MULTNOMAH COUNTY BUILDING DEPARTMENT
PLAN CHECK SHEET

Job Name Jerry Hoover

Location 16828 SE Kelly St

Date 5-27-64 Checked By [illegible]

3 OF 4

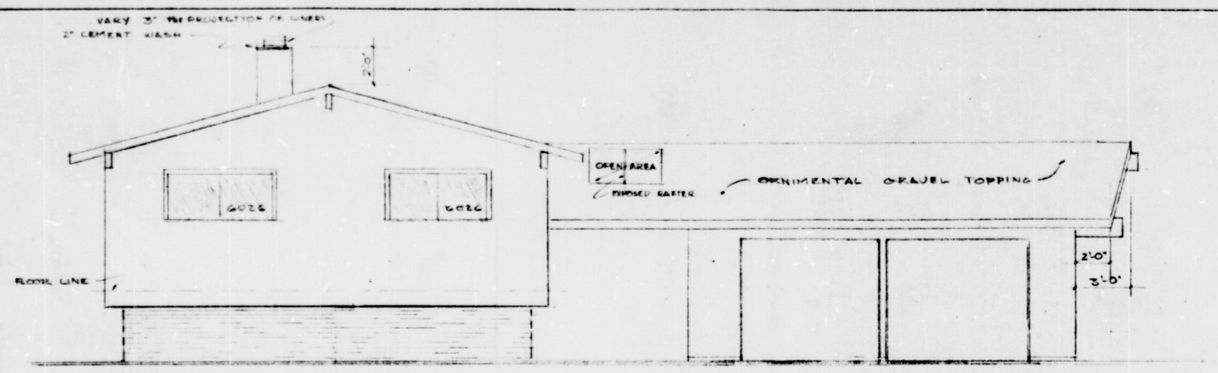
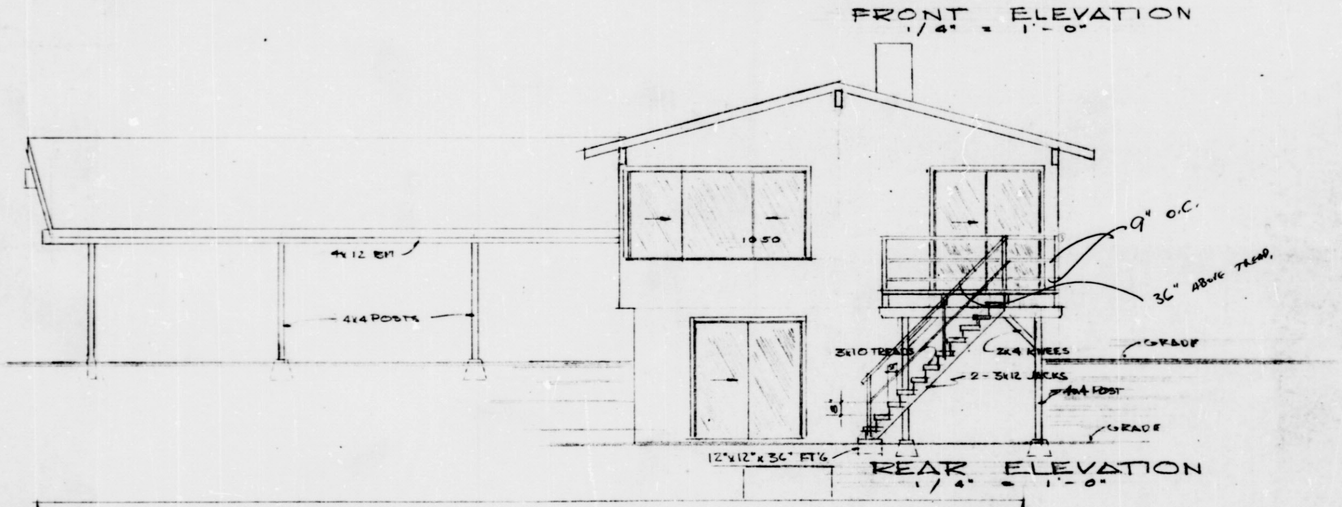
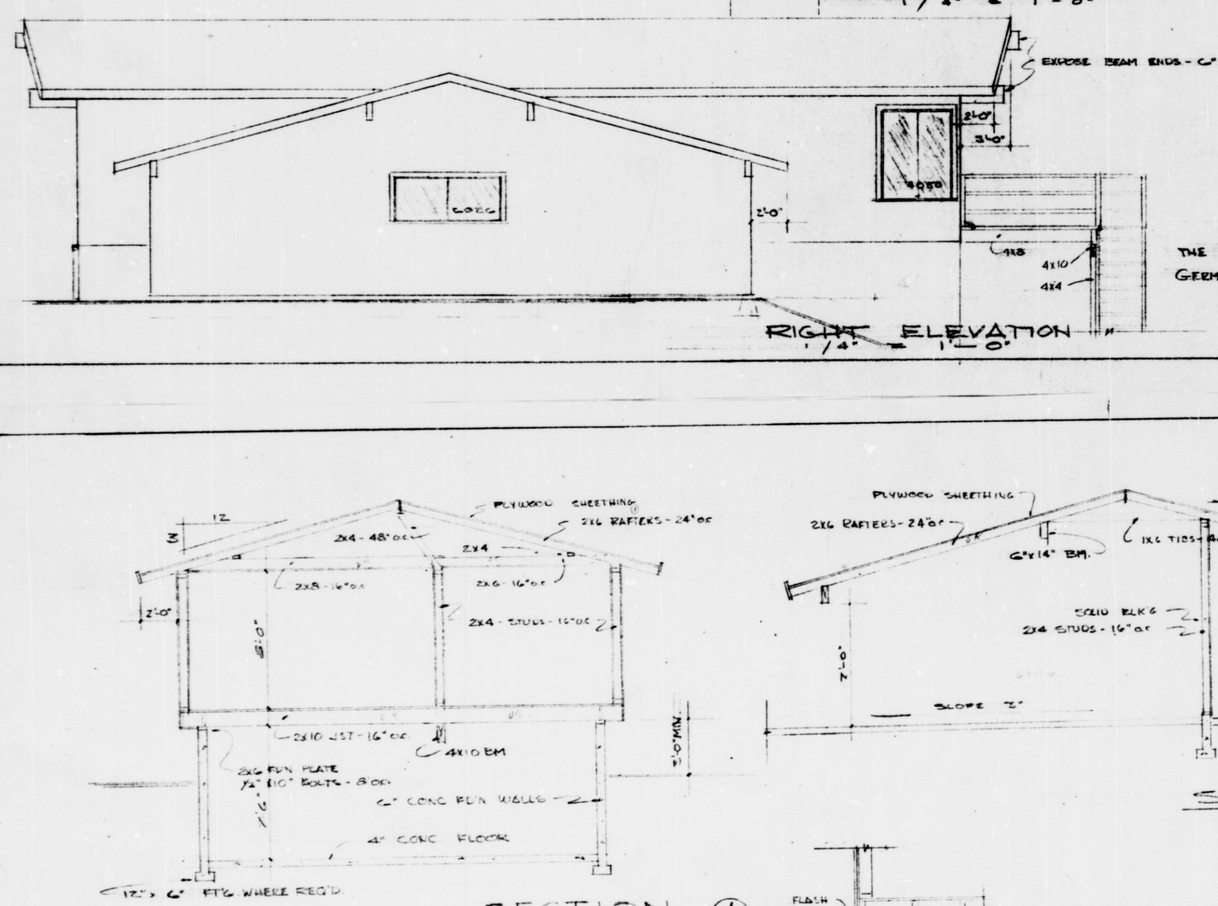
| Item No. | Page No. | Detail No. | Comments | Code Section No. |
|---|---|---|---|---|
| 3 | 3 | | deck hand rail 36" high | |
| | | | horizontal bars 9" o.c. | |

4 OF 4

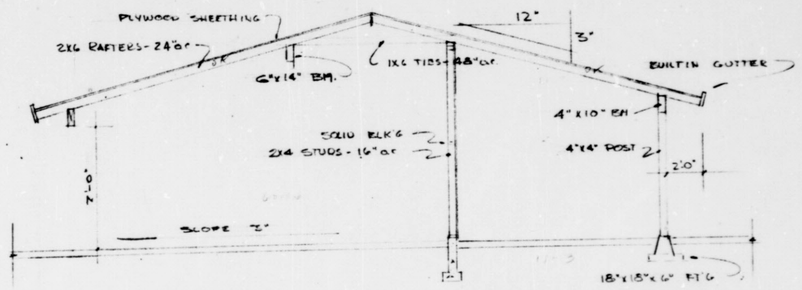
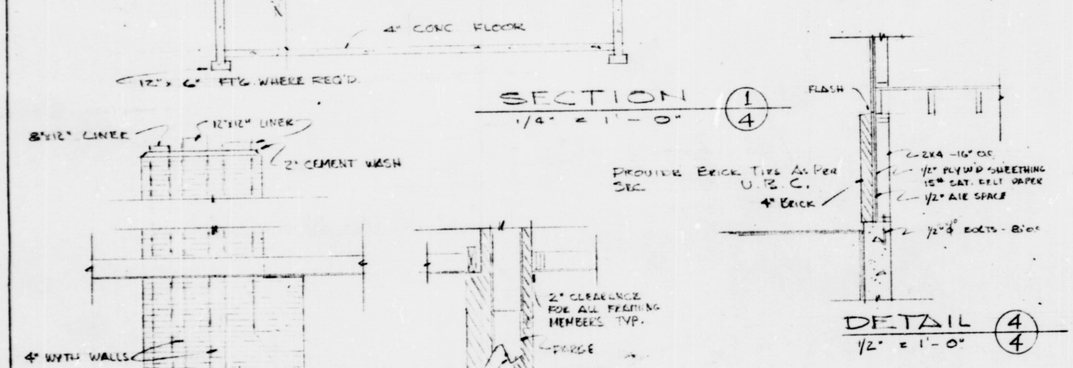
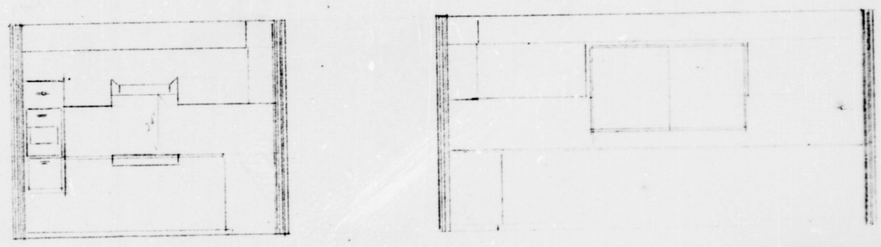
| Item No. | Page No. | Detail No. | Comments | Code Section No. |
|---|---|---|---|---|
| 1 | 4 | | [illegible] | |
| 2 | 4 | | [illegible] reference | 5102.0 |
| | | | Show doors shatter resistant | |
| | | | wind only on stairs 6 ft width | |
| | | | on top & stairs area | |
